Informal document No. **9**
(50th GRE, 7-11 April 2003,
agenda item 3.2.)

“CUT-OFF” LINE IN AFS DRAFT REGULATION

EXPLANATION TO INFORMAL DOCUMENT No. 8

INFLUENCE OF TOLERANCES OF VERTICAL AIMING ON LIGHTING RANGE AFS CLASS C (BASIC) PASSING BEAM

RESULTS OF DISCONTINUITY OF „SHOULDER LINE PART”

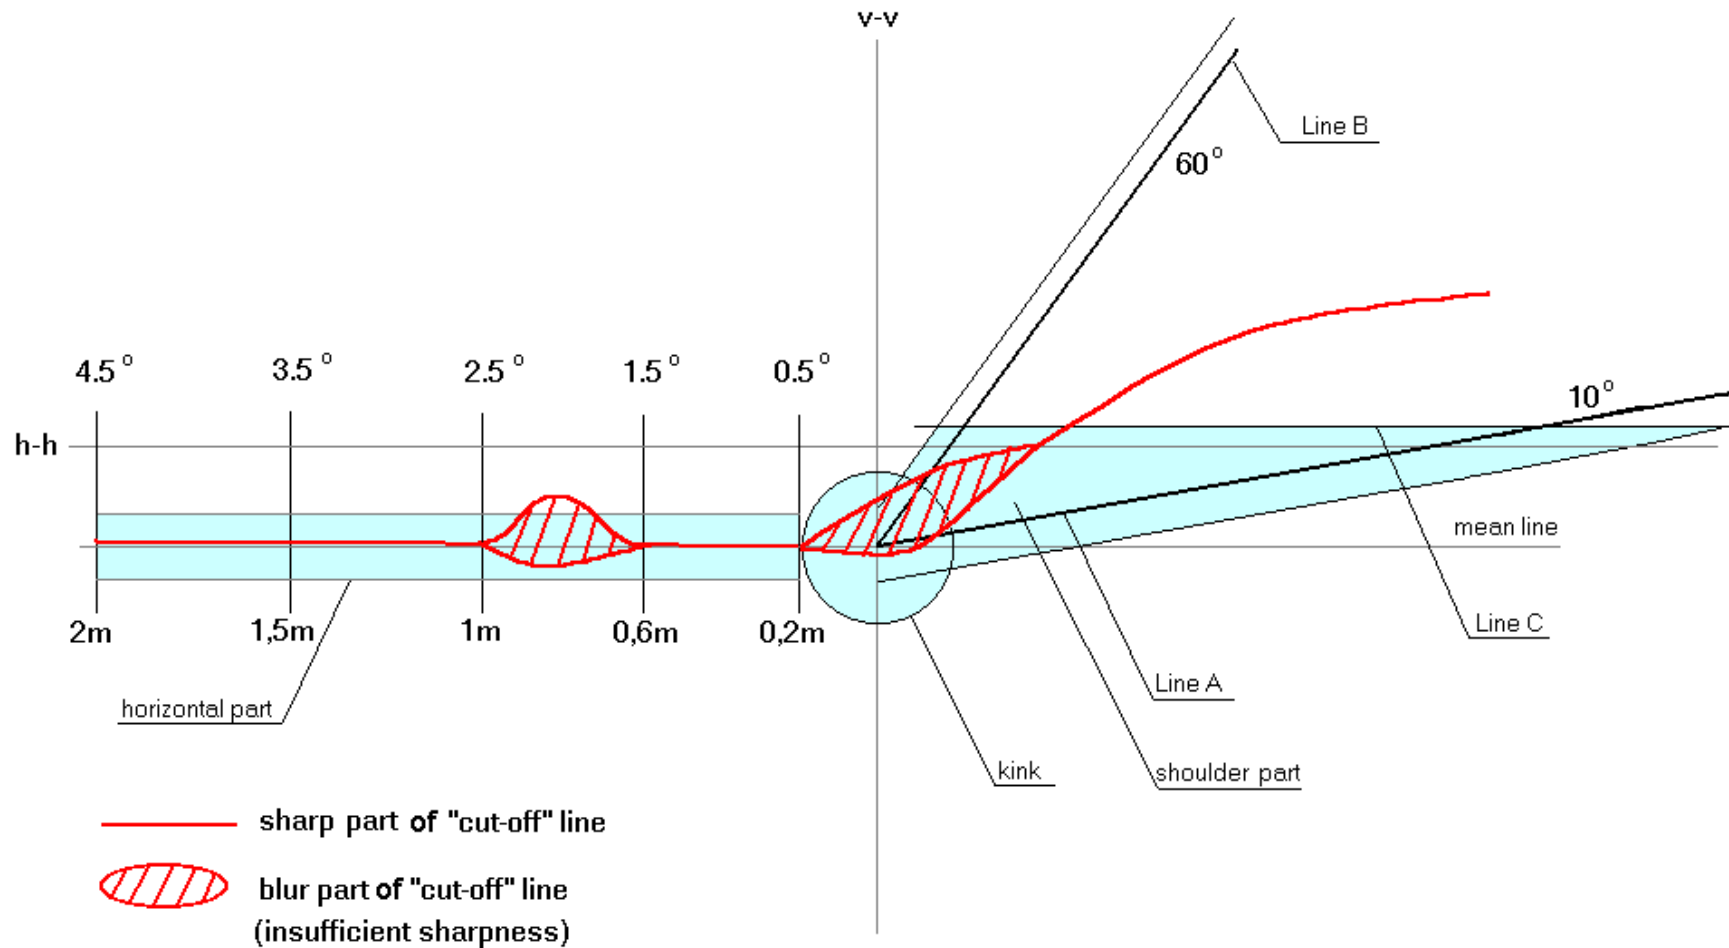
If there is discontinuity on the „shoulder line part” of „cut-off” line, there are two different possible ways of finding „kink point”:

- using visual approximation by prolonging slant part of „cut-off” line
- using 60deg tangential line

According to Draft XXX the quality of horizontal part of „cut-off” is checked in three points (1.5deg, 2.5deg, 3.5deg) only. Results will depend on this way.

Conclusion: If “horizontal part” of „cut-off” line has small blur part, then in one situation
_____ the „cut-off” line quality can be estimated as correct and in the other as
_____ incorrect depending on chosen way of finding „kink point”.

BLURRED „KINK POINT”

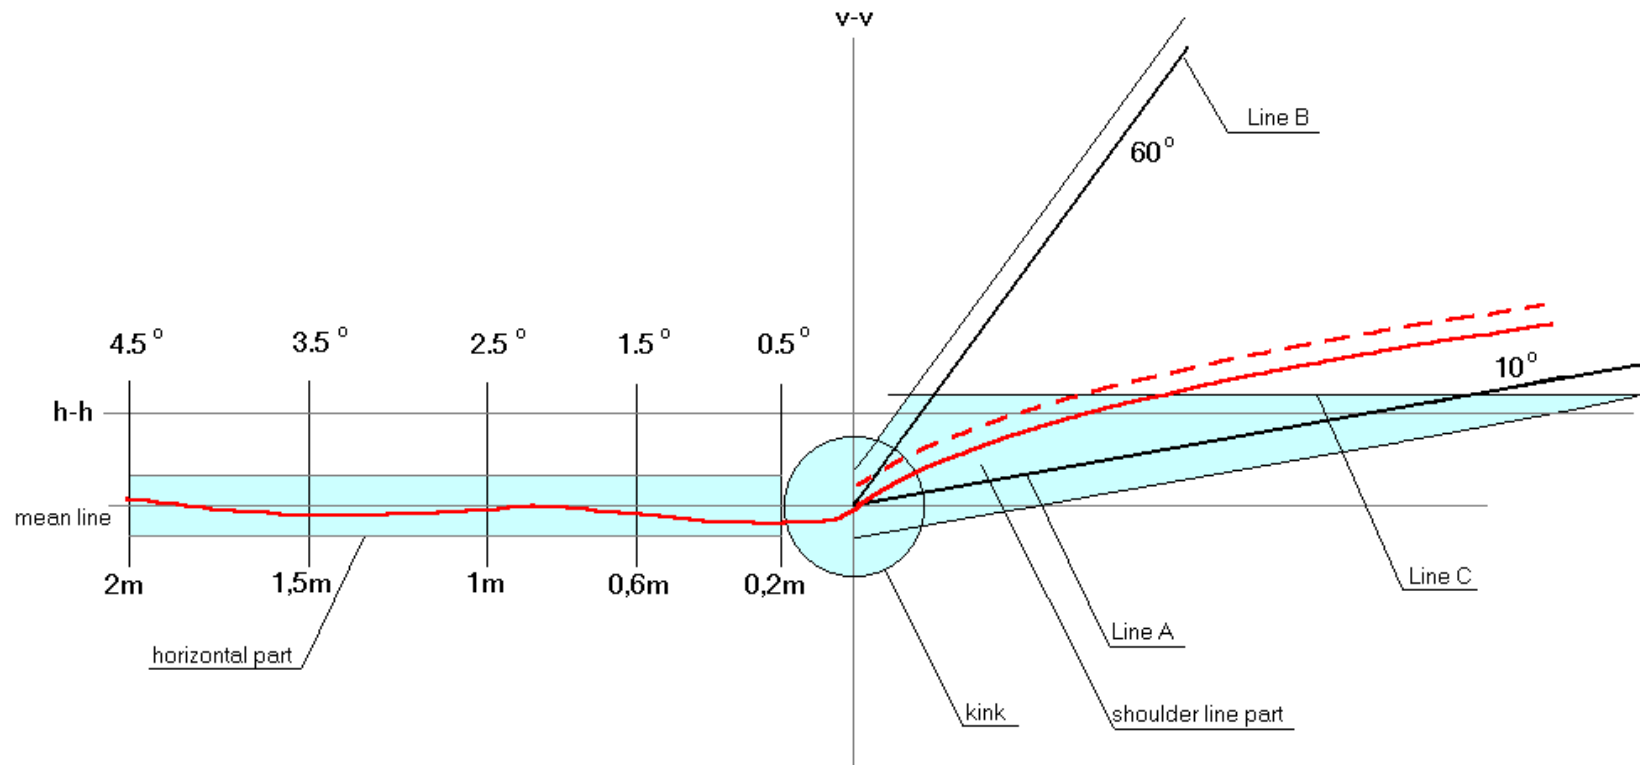
If the „kink point” is blurred it is difficult to locate correct place of „kink” and conclusion is similar to the previous example.

DOUBLE „SHOULDER LINE PART”

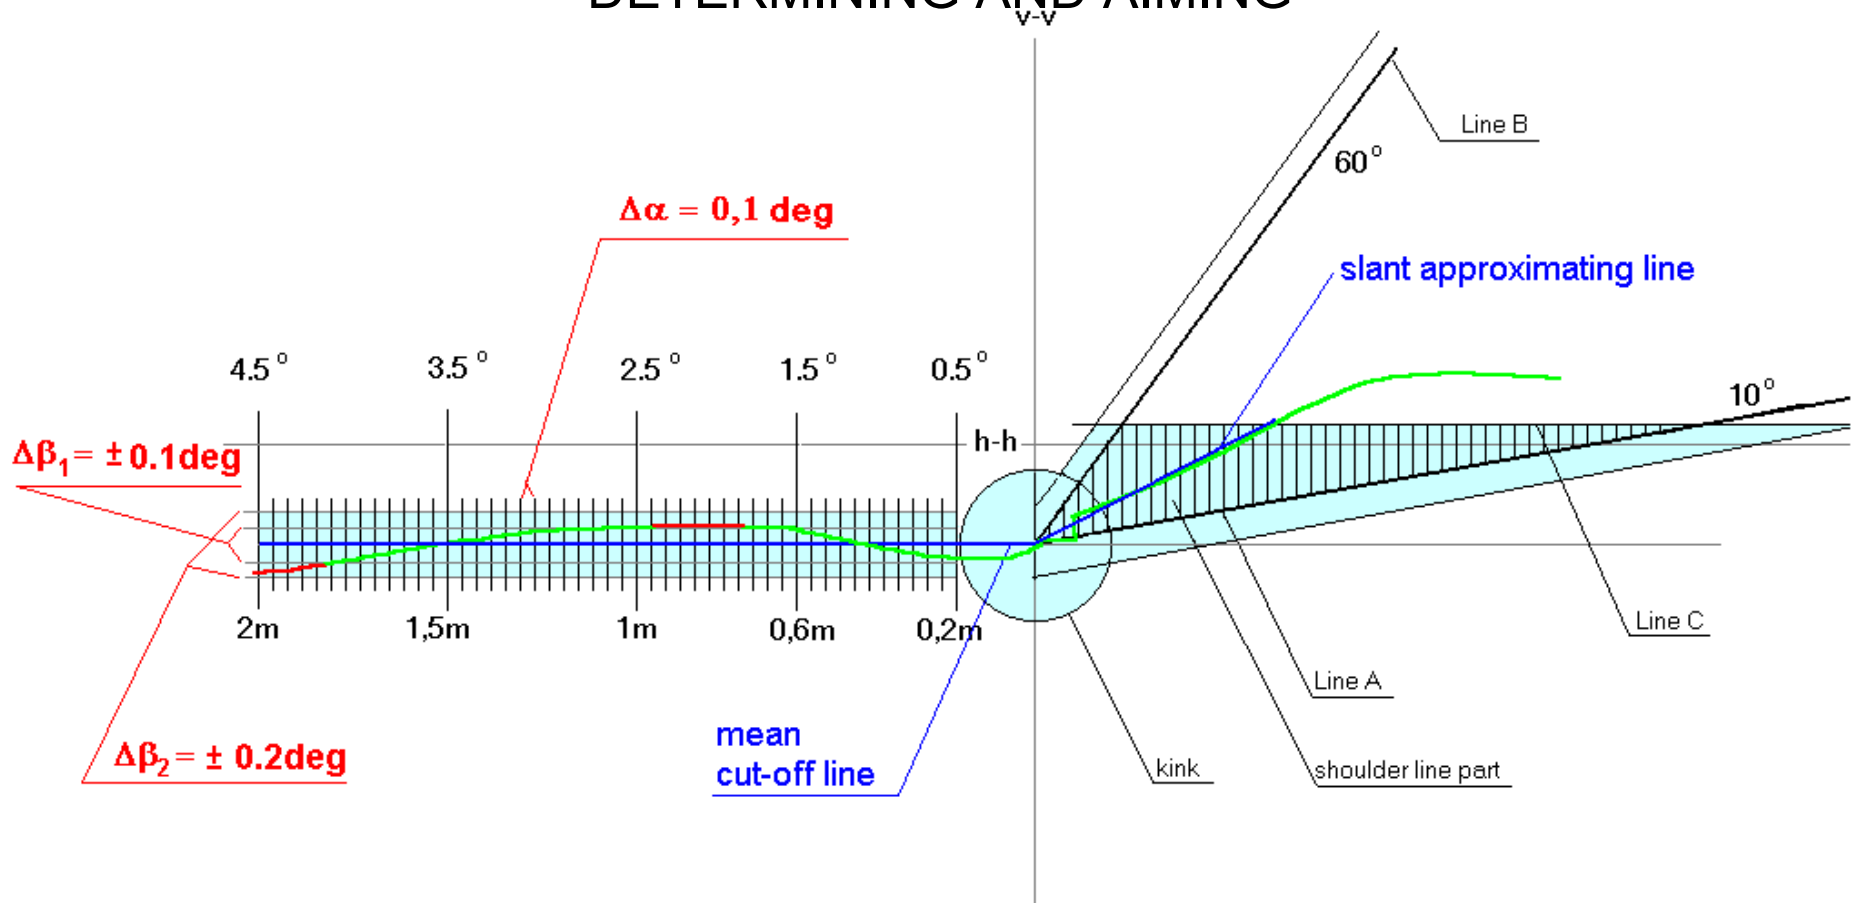
If there is a double „shoulder line part”, there is a double „kink point”.

PROPOSAL OF IMPROVING THE METHOD OF CUT-OFF LINE DETERMINING AND AIMING

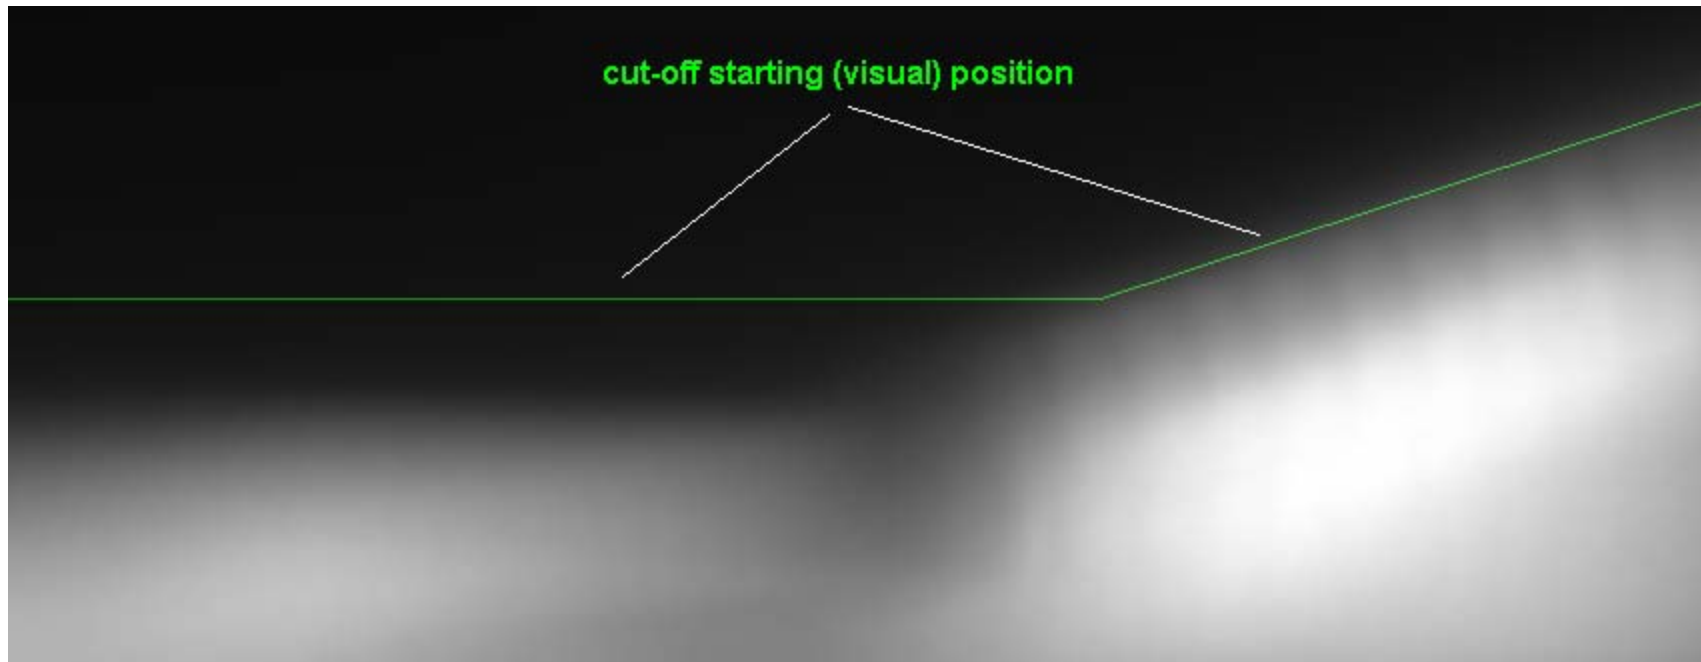
Proposals of changes:

1. Vertical scanning „cut-off” line every 0.1deg
2. Tolerance range of the most „horizontal part” should be ± 0.1 deg.
3. 80% of „horizontal part” should be placed within ± 0.2 deg tolerance range.
4. „Shoulder line part” should be approximated by slant line.

INSTRUMENTAL APPROXIMATION OF "CUT-OFF" LINE

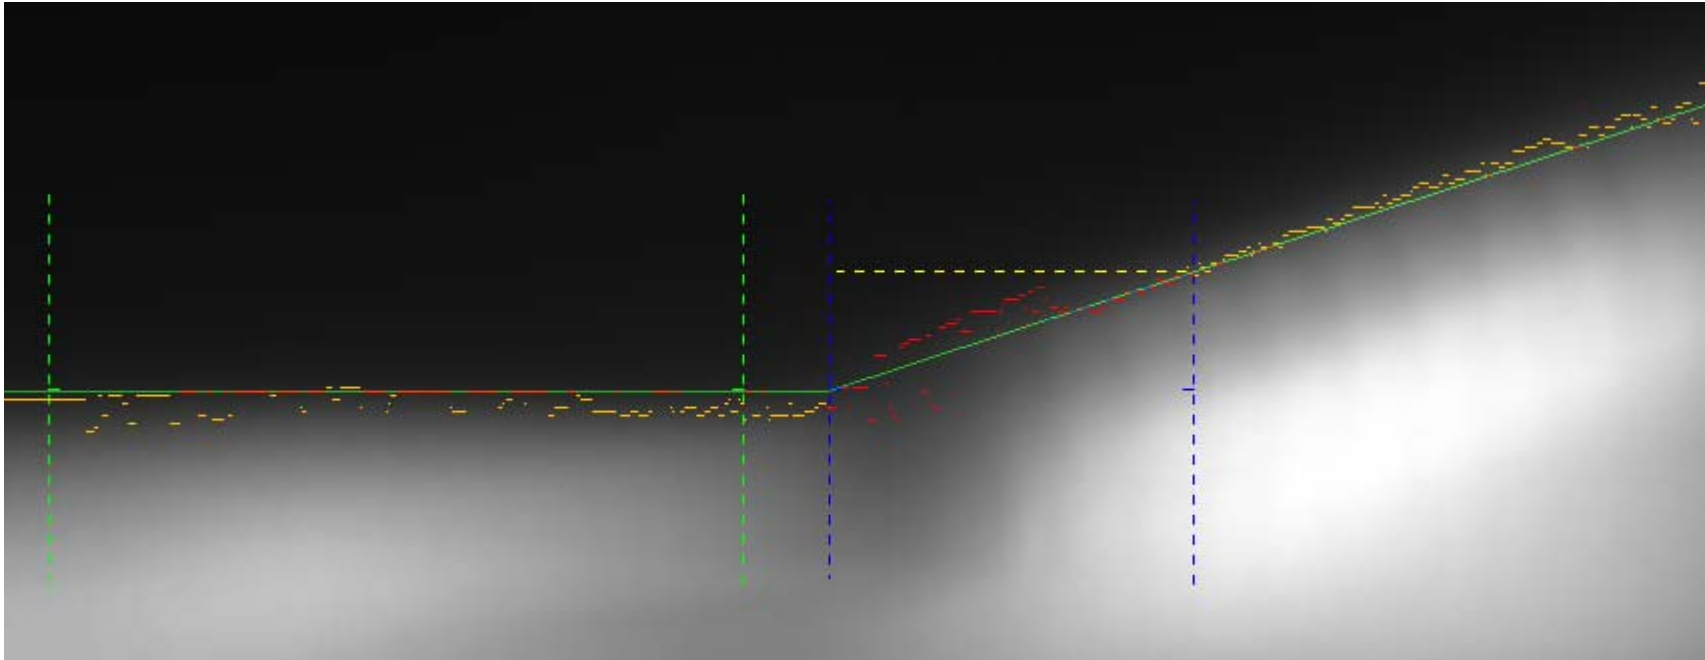
Result of instrumental adjustment procedure, according to
TRANS/WP.29/GRE/2002/44 Rev 1. Annex 9 p. 4.3.

Conclusion: Instrumental approximation of "cut-off" line is very
consistent with average visual position of "cut-off" line.

DISCONTINUITY ON „HORIZONTAL PART”

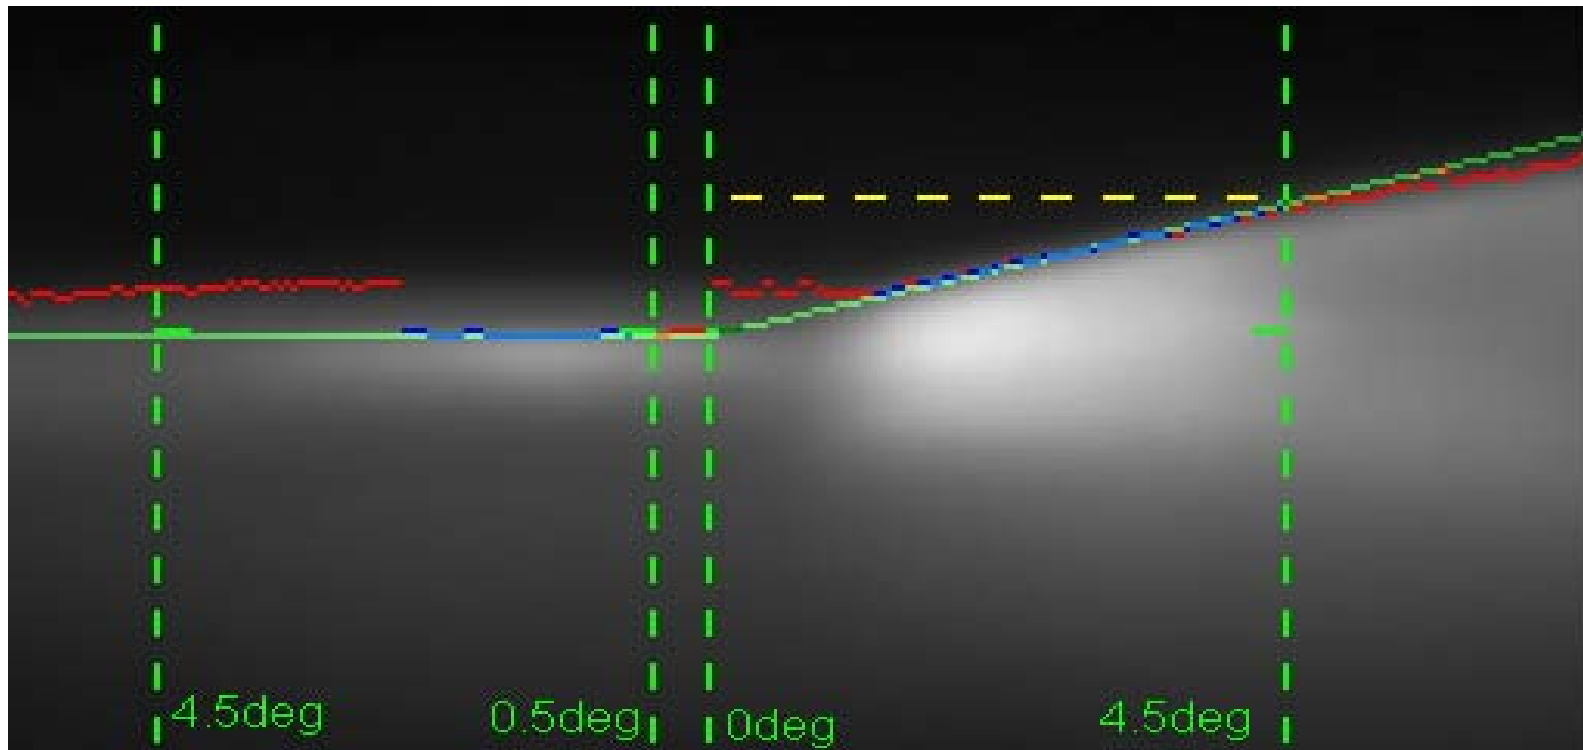
Remark: Please, pay attention to multiplied “kink points”, different kinds of
_____ “kink points”, linear approximations of “shoulder line parts” and
_____ distances between “kink points” and maximums of illumination.
